**CITY OF SEATTLE
ANALYSIS AND RECOMMENDATION OF THE DIRECTOR
OF THE DEPARTMENT OF PLANNING AND DEVELOPMENT**

Application Number: 3012582
Council File Number: CF#311813
Applicant Name: Via Architecture for Aegis Living
Address of Proposal: 223 W Galer St

Council Land Use Action to Contract Rezone 12,800 sq. ft. of land from NC2-30' to NC2-40'. Project includes a 4-story structure containing 60 assisted living units above 509 sq. ft. of street level retail and 10,000 cu. yds. of grading. Parking for 21 vehicles to be provided below grade. Existing structure to be demolished.

(at the Early Design Guidance meeting on October 5, 2011)

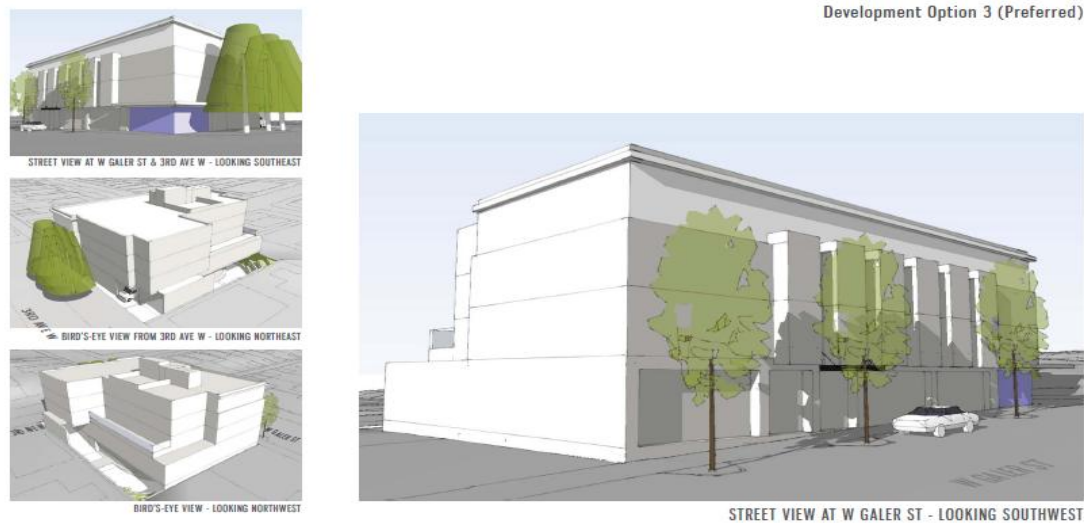
Three alternative design schemes were presented. All of the options include a retail space at the corner of 3rd Ave W and W Galer St.
